M E M O R A N D U M

TO: Casey Adragna, Adragna Architecture
FROM: Elizabeth Steward, Associate Planner- Development Review
DATE: 6/18/26
SUBJECT: Douglas 234 Multitenant, Site Plan
Review Comments 04

LOT 10B, DOUGLAS 234 FILING NO. 6, AMENDMENT 2
HORSE CREEK COMMERCIAL SITE PLAN
LOCATED IN THE SW 1/4, SE 1/4, SECTION 29, T6S, R66W, 6TH P.M.
TOWN OF PARKER, COUNTY OF DOUGLAS, STATE OF COLORADO
PAGE 1 OF 15

SITE PLAN
LOT 10B, DOUGLAS 234 FILING NO. 6, AMD. 2
JOB NO. 24020
DATE: JUNE 2, 2026
SHEET C3

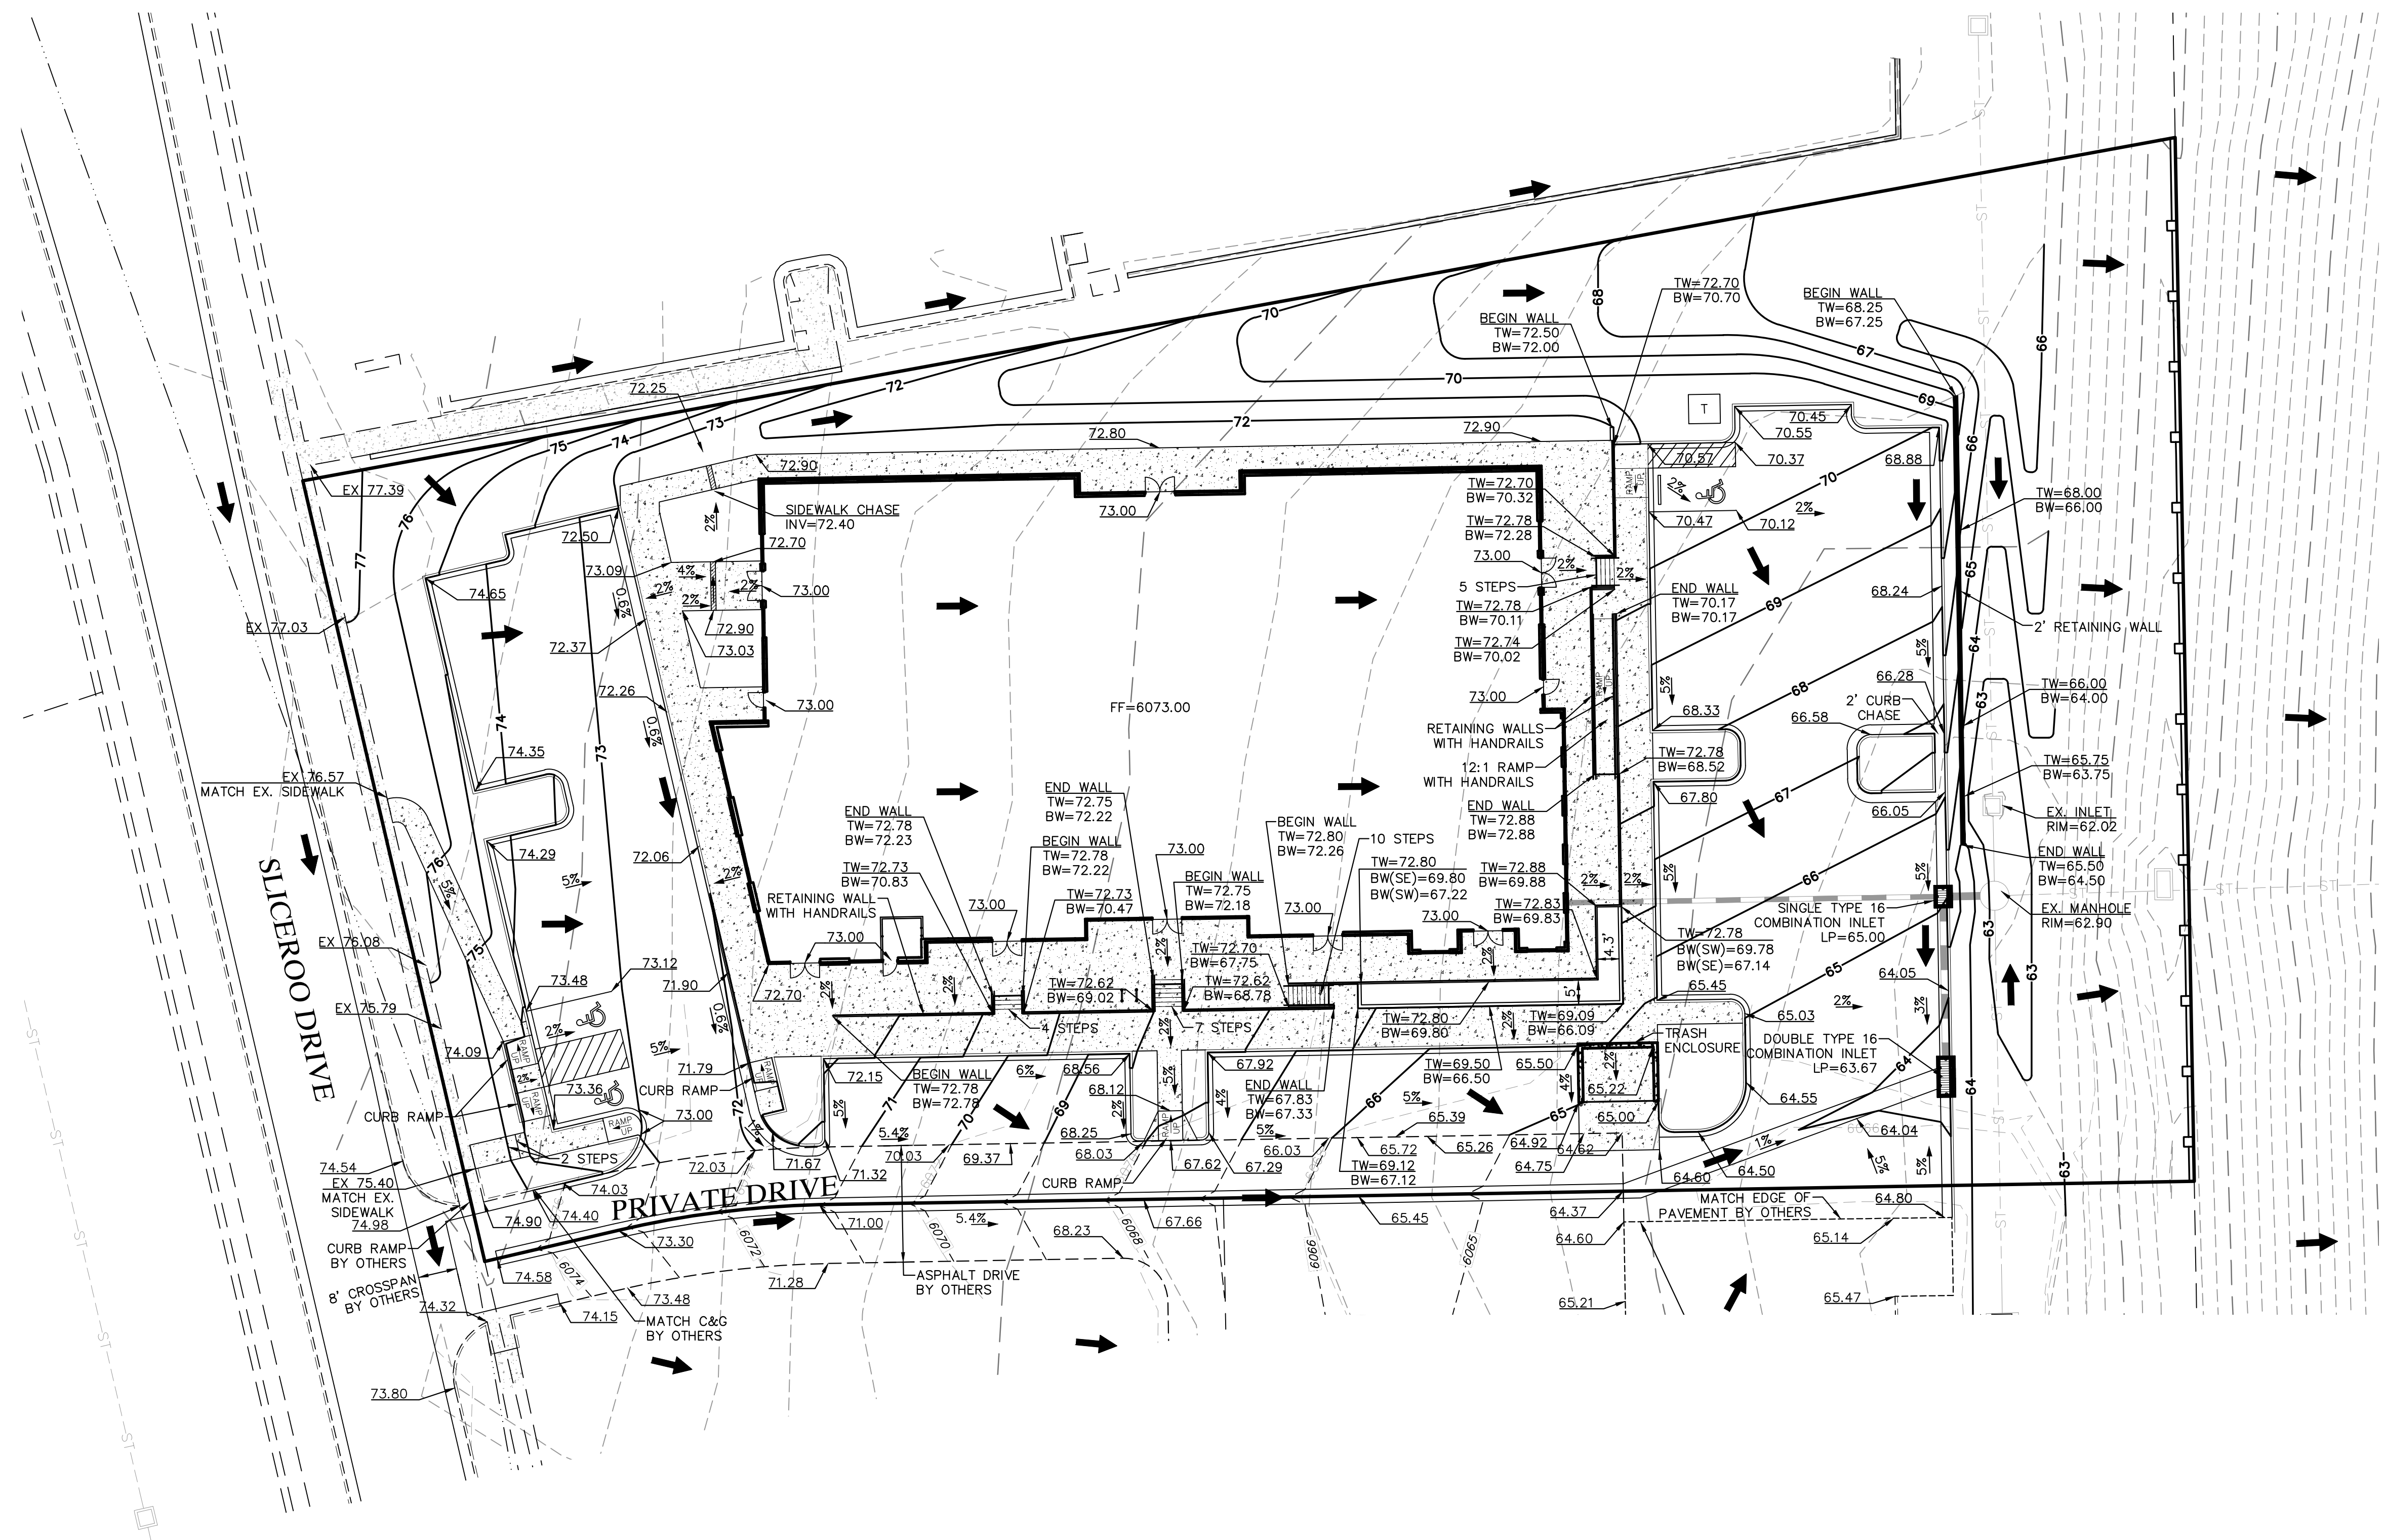
3. The separation between retaining walls must be increased to meet the minimum terrace width requirement. Section 13.08.090 requires a minimum five-foot horizontal terrace between retaining walls. Areas currently shown at 4.3 feet do not meet this standard and must be increased by at least 9 inches to achieve the required five-foot separation. Please revise the plans accordingly.

LANDSCAPE PLAN
LOT 10B, DOUGLAS 234 FILING NO. 6, AMD. 2
JOB NO. 24020
DATE: JUNE 2, 2026
SHEET L1

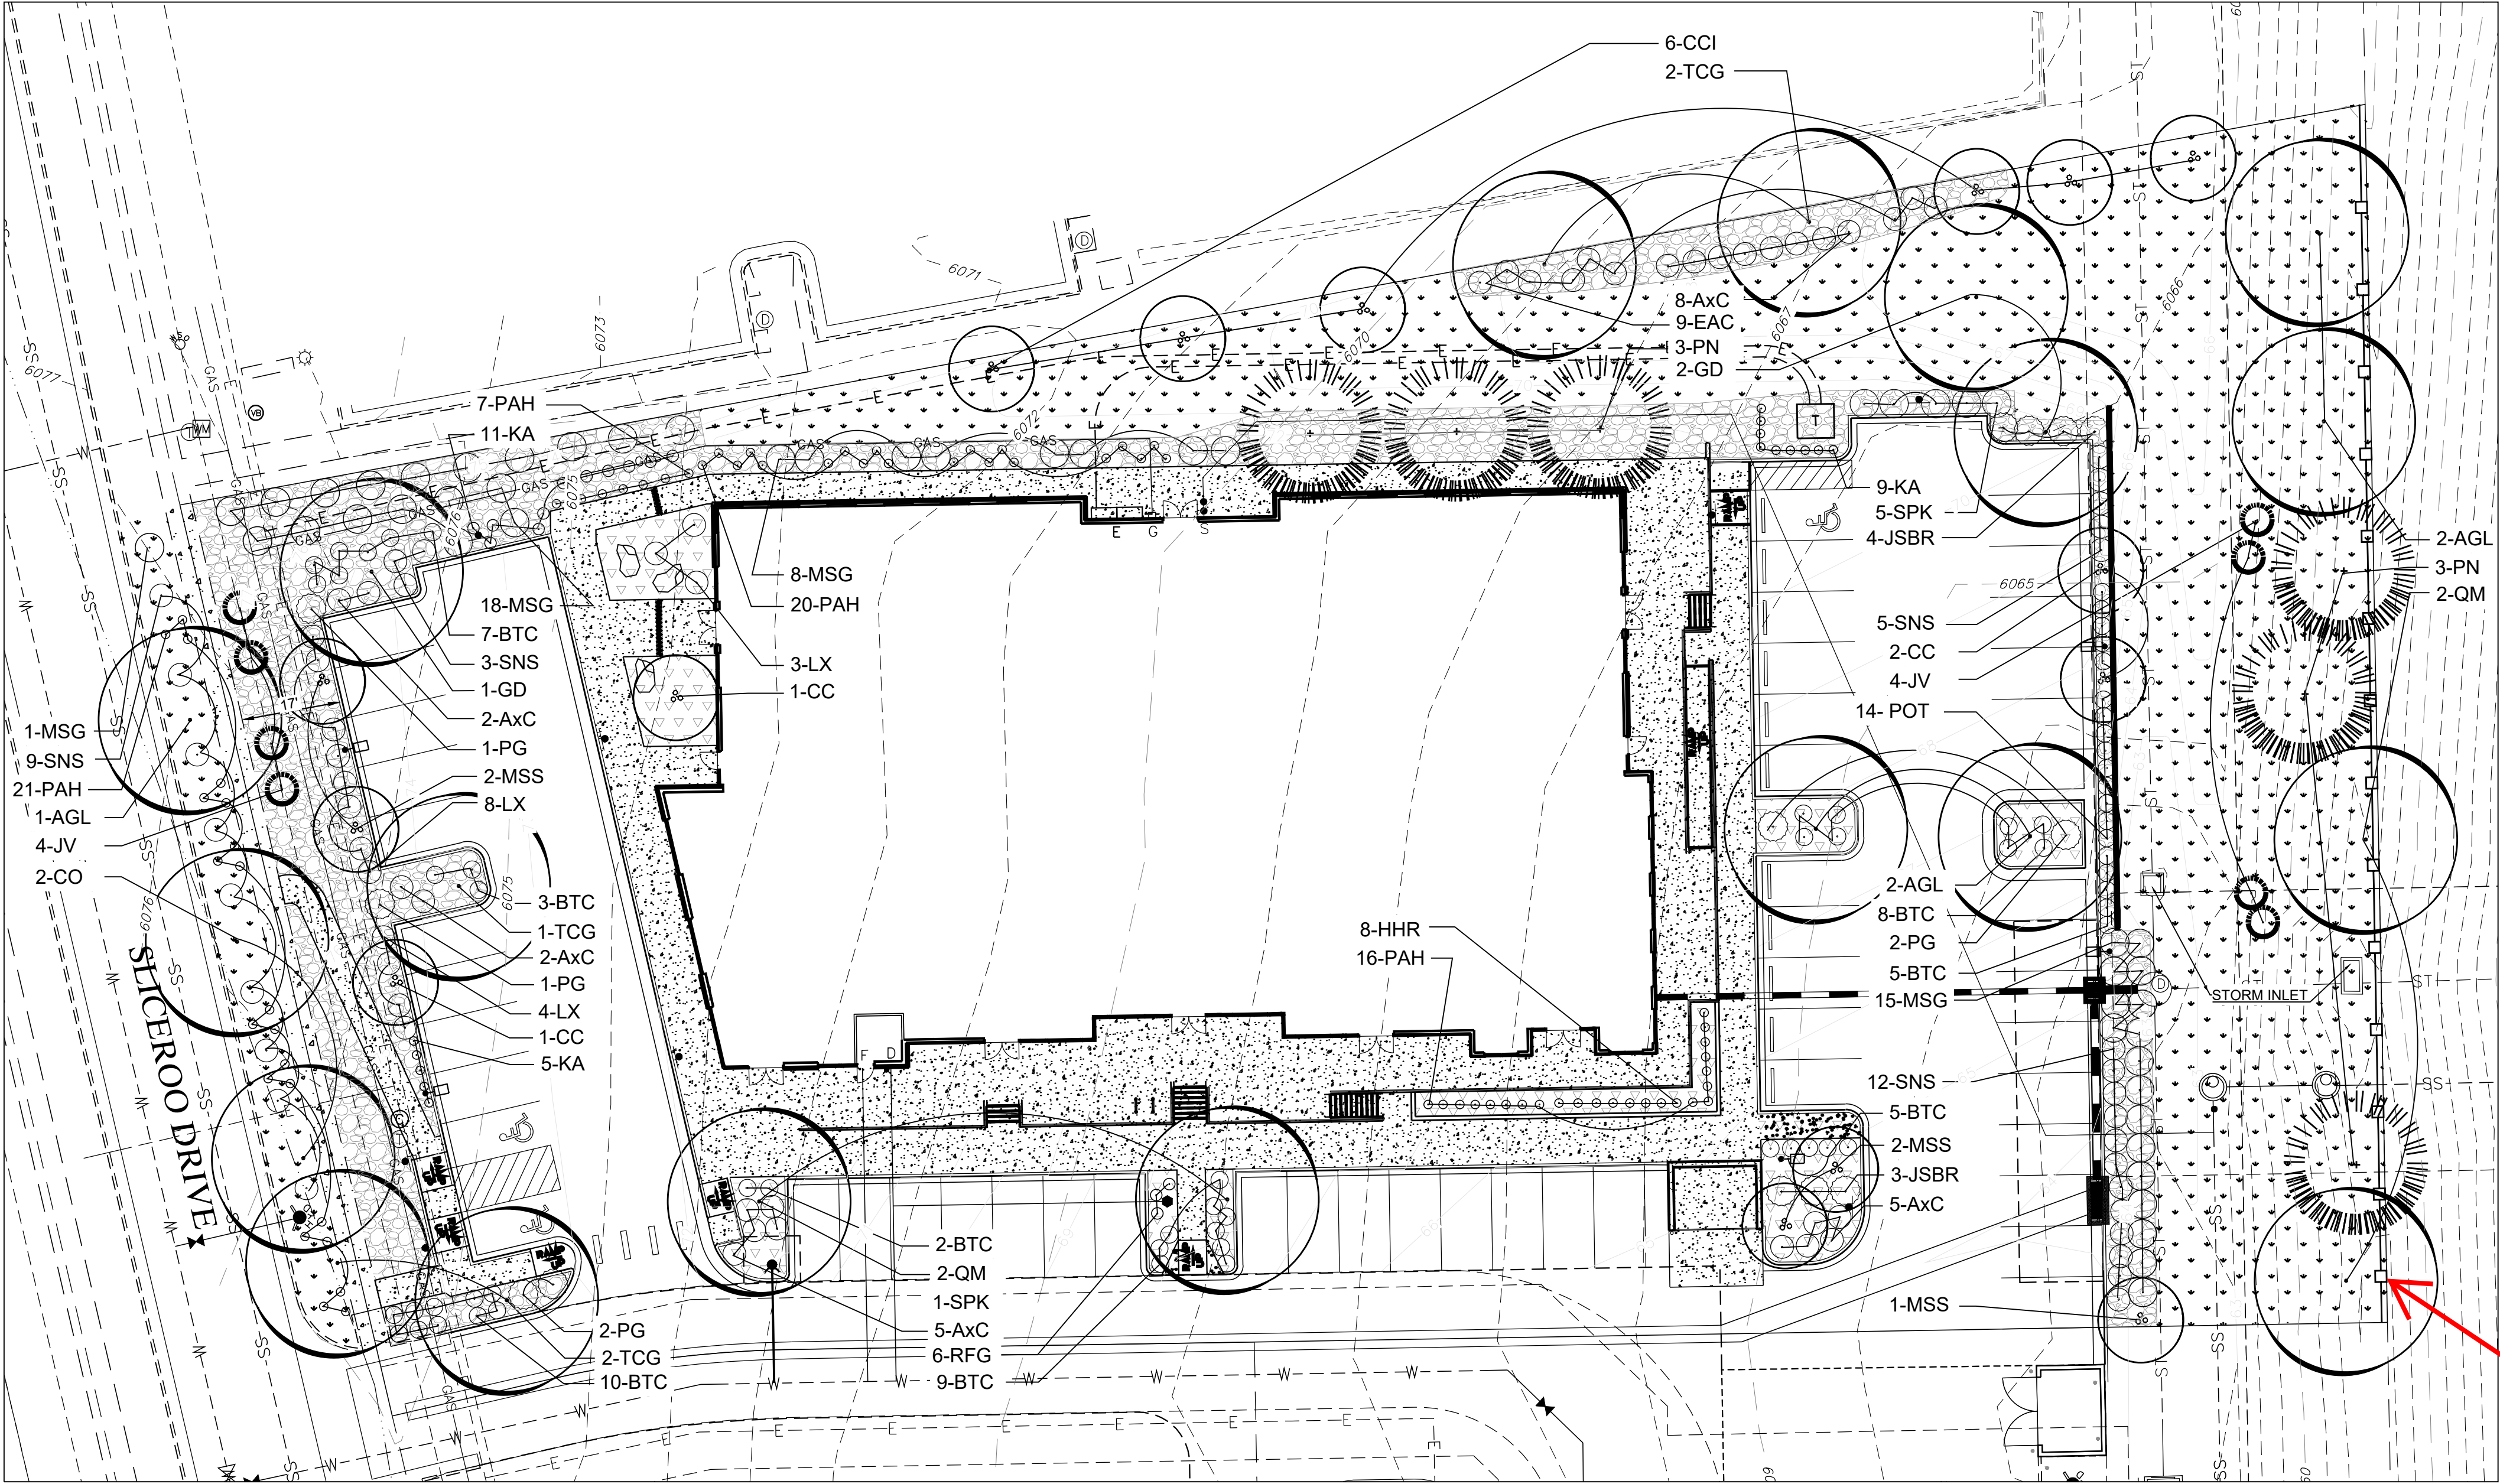
- 3. To improve clarity and ease of review, please revise the buffer table so that the "Location" column precedes the "Buffer Type" column.**

Can you switch the order of the buffer type and location columns to make reading the chart easier?

D CEDAR PRIVACY FENCE

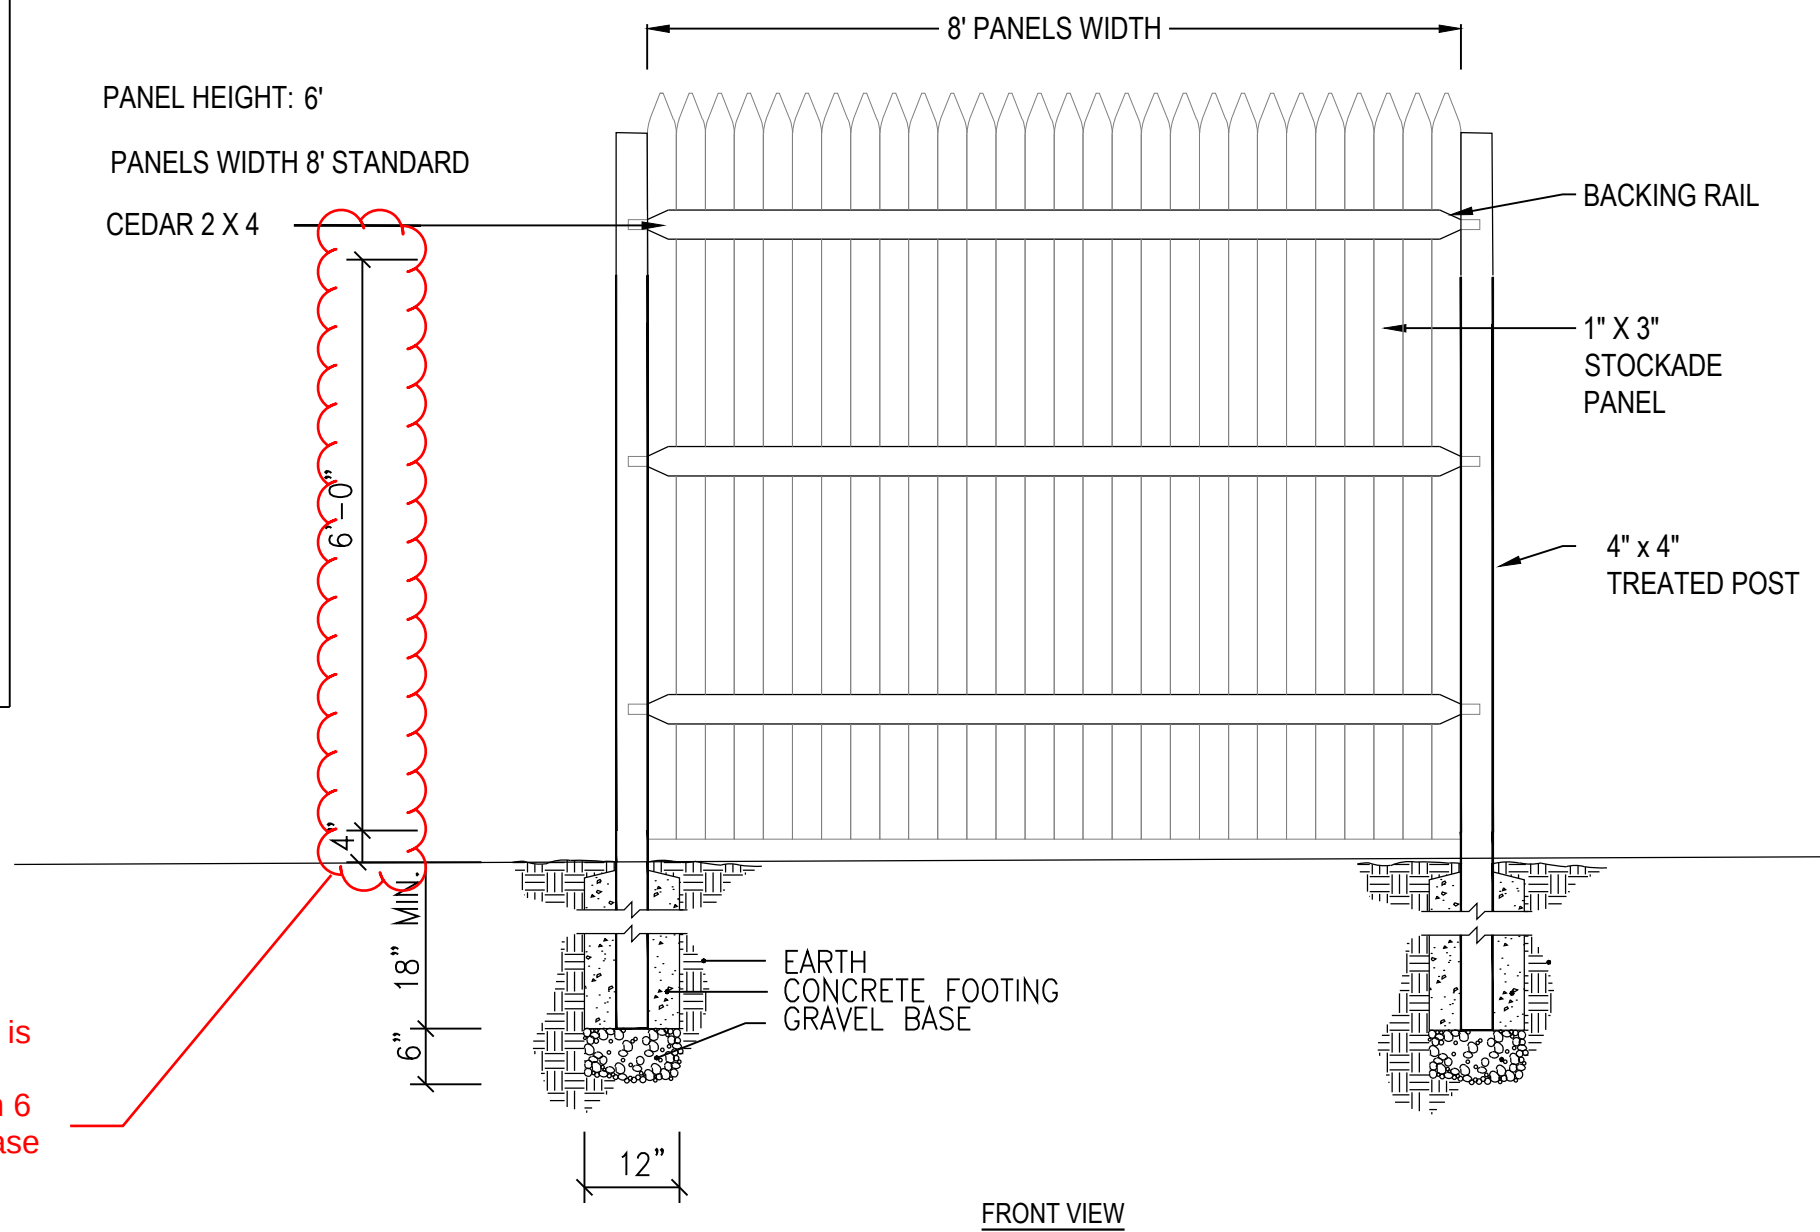
1. Please label the fence location and maximum height on the plans. Fence height shall not exceed six (6) feet.

this measurement is implying that the fence is taller than 6 feet in height, please confirm the total fence height
